Three Mile Island Nuclear Station, Unit 2 (TMI-2)
Operating License No. DPR-73
Docket No. 50-320
Processed Water Disposal System Technical Evaluation Report

Attached is GPU Nuclear's responses to your request for additional information regarding the Processed Water Disposal System Technical Evaluation Report, dated February 16, 1989.

The following simplified process flow diagram shows the flowrates and projected total solids concentrations at the key points in the system:

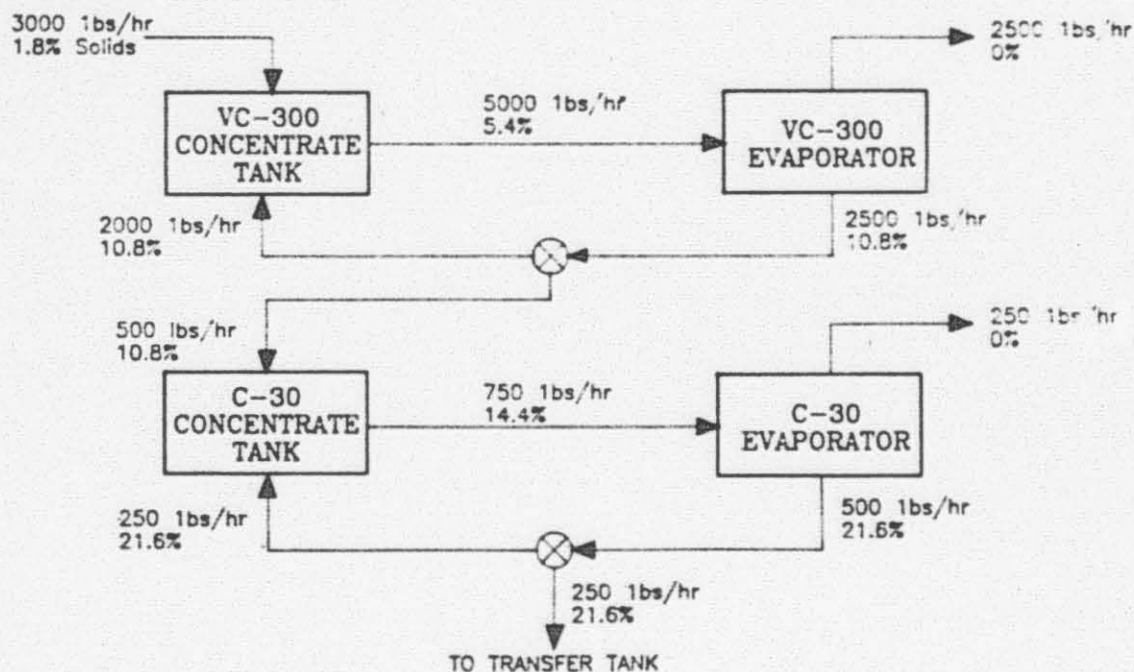
Provide the maximum quantity of radionuclides and maximum volume of solution that will be present in liquid evaporator bottoms at any time during evaporation. Be sure to include solutions that might result from using the evaporator in lieu of ion exchange pre-treatment.

The volumes of liquid solution that will be present in the evaporator system are as follows:

- The VC-300 evaporator shell has a volume of about 145 gallons if completely flooded. During normal operation it will contain on the order of 50 to 90 gallons of liquid.
- The VC concentrate tank has a volume of about 75 gallons. Its normal operating level is 50 to 65 gallons.
- The C-30 evaporator shell has a flooded volume of about 8 gallons with an operating level of 5 to 6 gallons.
- The C-30 concentrate tank has a volume of about 35 gallons with an operating level of about 25 to 30 gallons.
- The transfer tank has a volume of 130 gallons with an operating level of 40 to 90 gallons.

This is based on processing "Base Case" water. Thus, the radionuclide concentrations in the liquid bottoms are as follows:

- VC Concentrate Tank: about 3 times "Base Case"
- VC Evaporator Shell: 5 to 7 times "Base Case"
- C-30 Concentrate Tank: about 8 times "Base Case"
- C-30 Evaporator Shell: 10-12 times "Base Case"
- Transfer Tank: 10-12 times "Base Case"
